April 10th, 2024

CHELAN COUNTY NATURAL RESOURCE DEPARTMENT
EAGLE CREEK CULVERT REPLACEMENT PROJECT

ADDENDUM NO. 2

EXISTING CONDITIONS MORTON

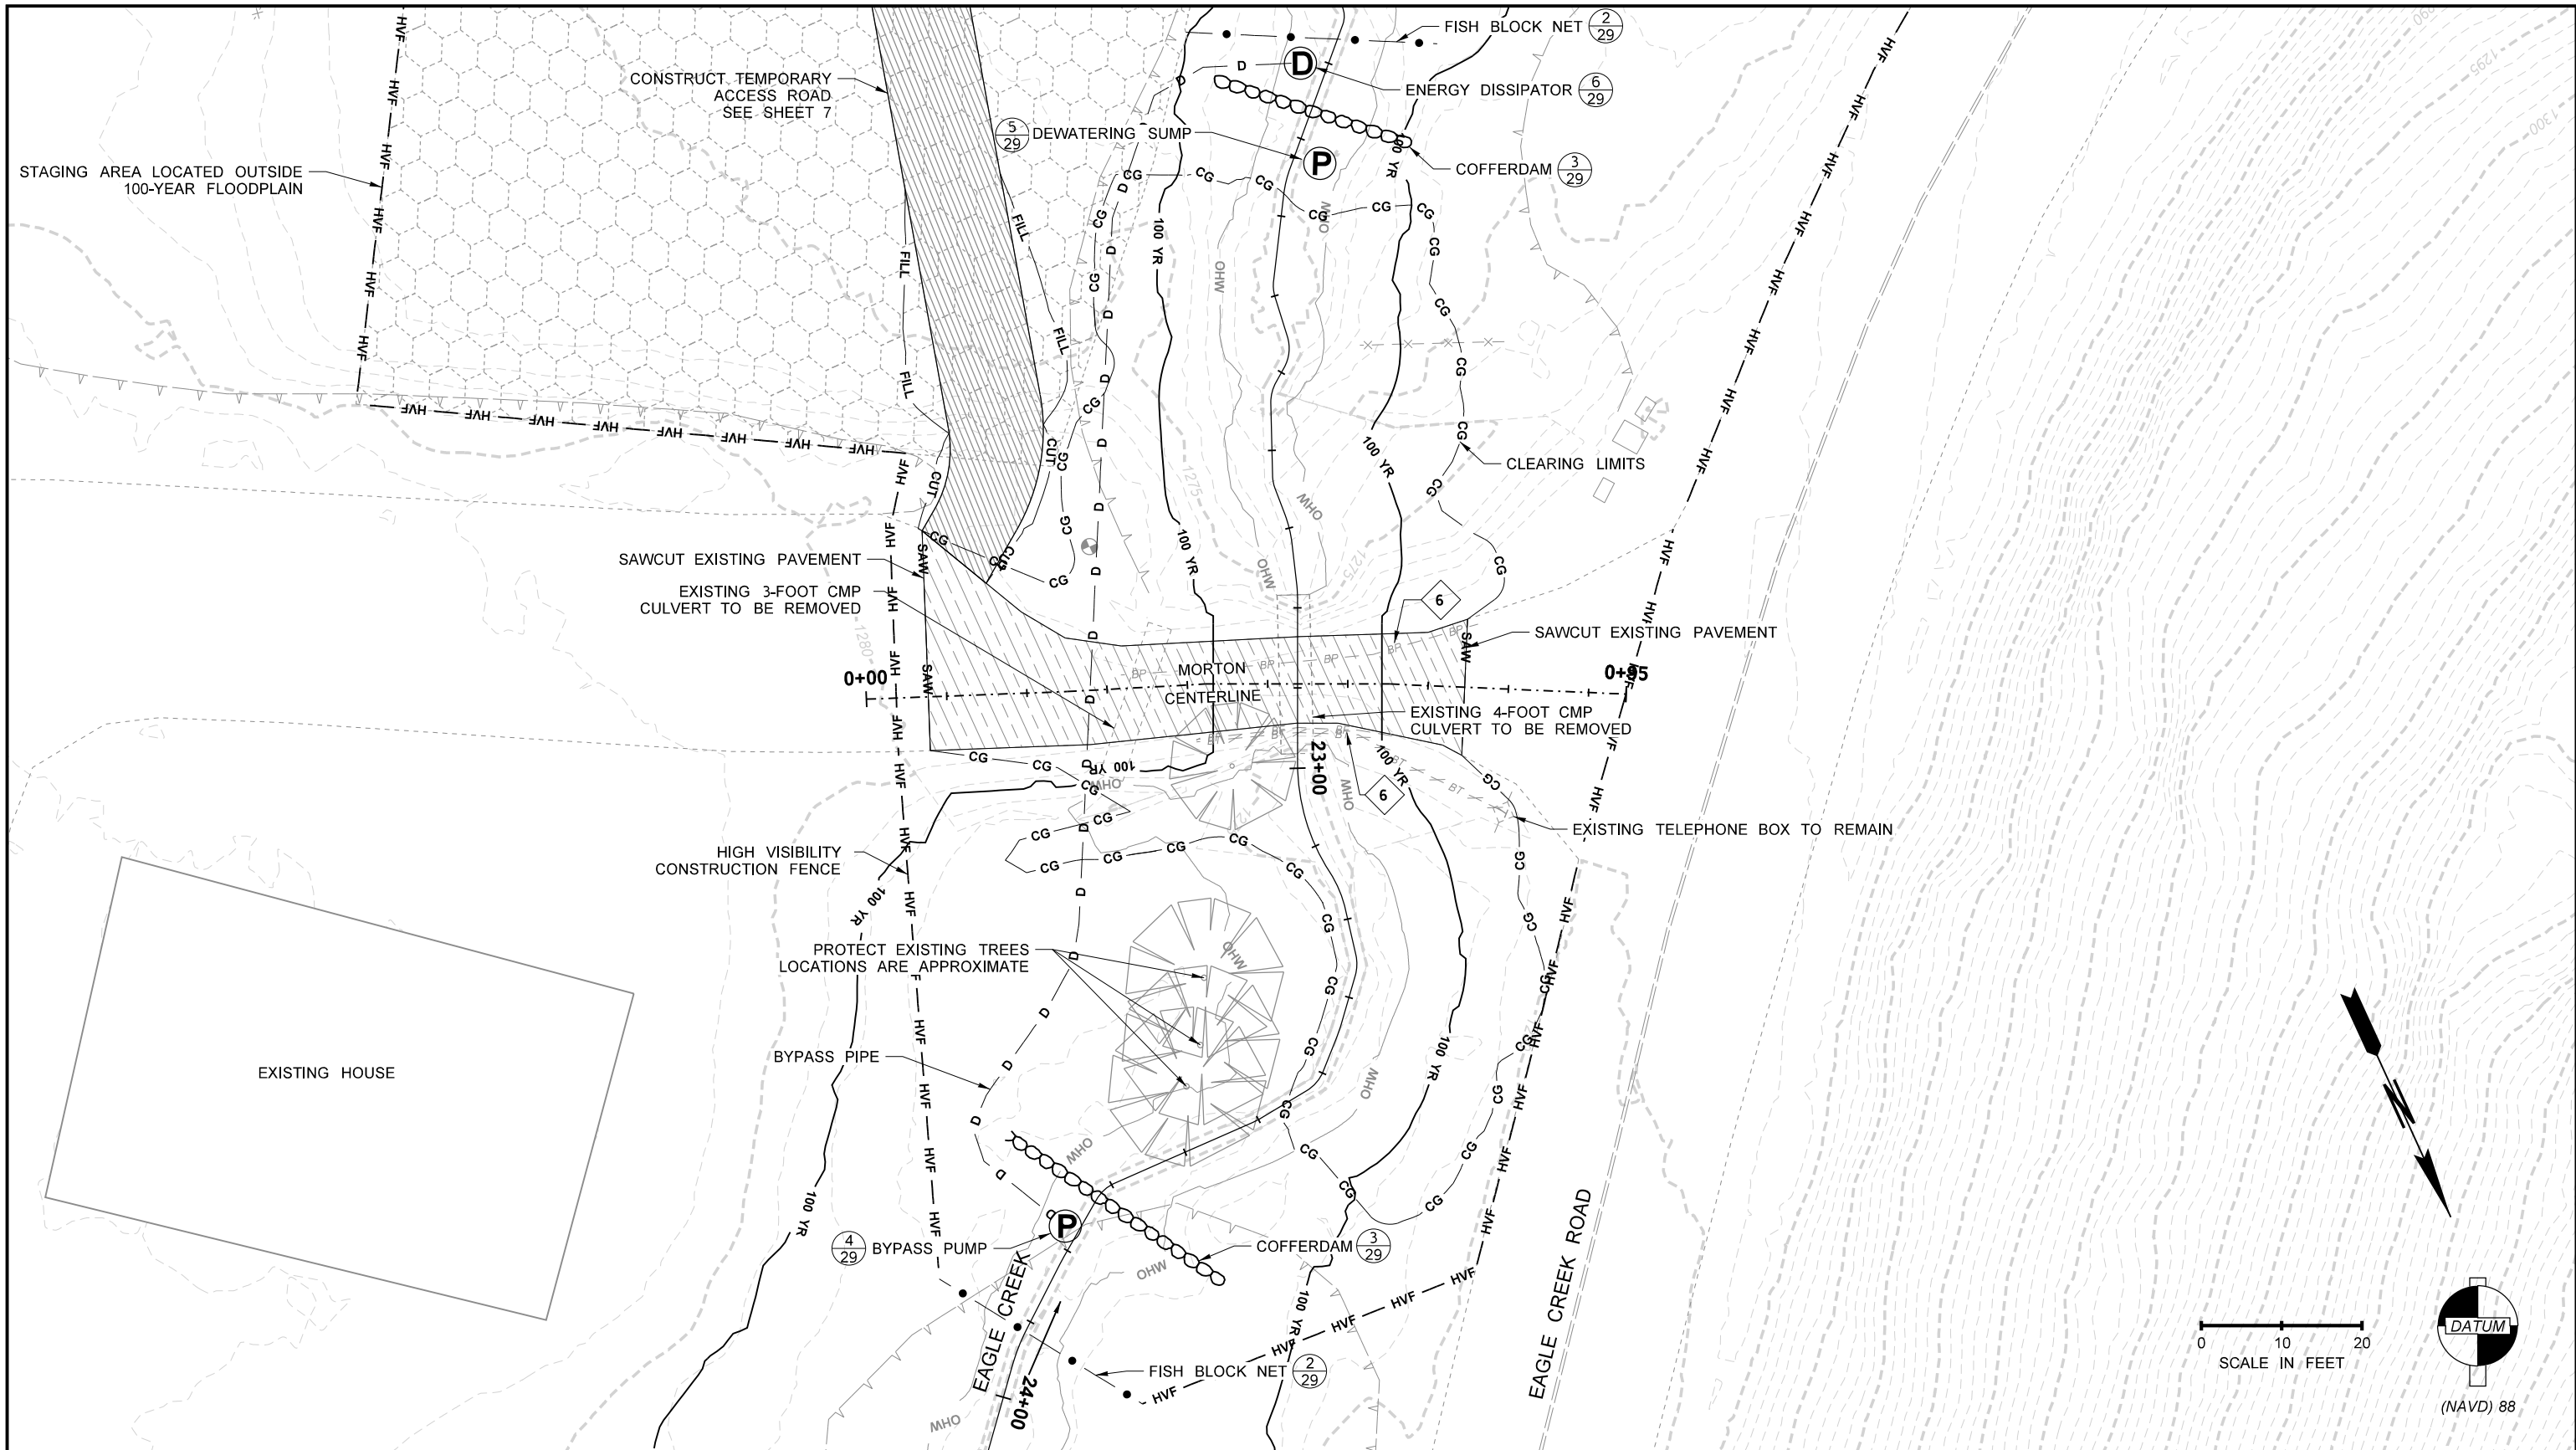
The Legend on Sheet 2 is updated to reflect the addition of “Inactive Buried Telephone Line.” Sheet 24 is updated to reflect the presence of an inactive buried telephone line that is currently present at the Morton Site. This shall be cut and left in place if encountered during construction.
